INITIAL FIRE SAFETY INSPECTION REPORT

Hannan Knit & Textiles Ltd. (Extension)

RSC ID: 25763

Date: 21 October 2024

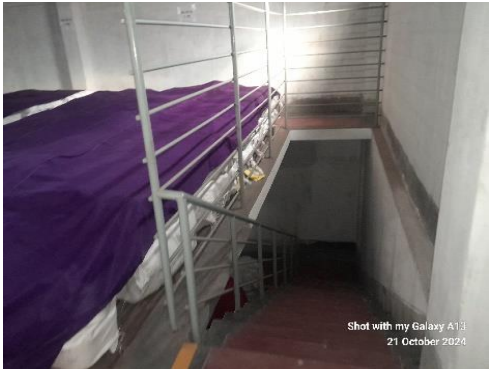
Sl No.	Category	Findings	Required Action	Remediation Time Frame
F-1	Mean of egress	Exit stairs are not separated from work areas & other spaces on each floor by fire-rated construction. Location: Two Storied Yarn Store	The exit stair enclosure shall be provided with a minimum 1-hr fire resistance rating with 1- hr. fire rated door and seal all penetrations and openings by 1 hr. fire rated materials. Ensure that the fire doors are self-closing and positive latching and that they are provided with fire exit (panic) hardware where serving production floors. If fire doors are required to be held open for functional reasons, provide automatic closing devices tied to the fire alarm system.	Within 3 months

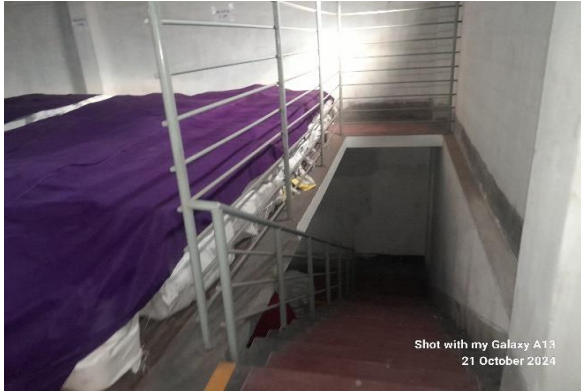
F-2	Means of egress	Exit stairs do not discharge directly to the outside. Location: Both exit stair of the two storied yarn store	Modify stair to discharge directly outside. Or Provide 1-hr fire-rated exit passageway leading directly outside (vestibules to separate any storage areas).	Within 3 months
-----	-----------------	---	--	-----------------
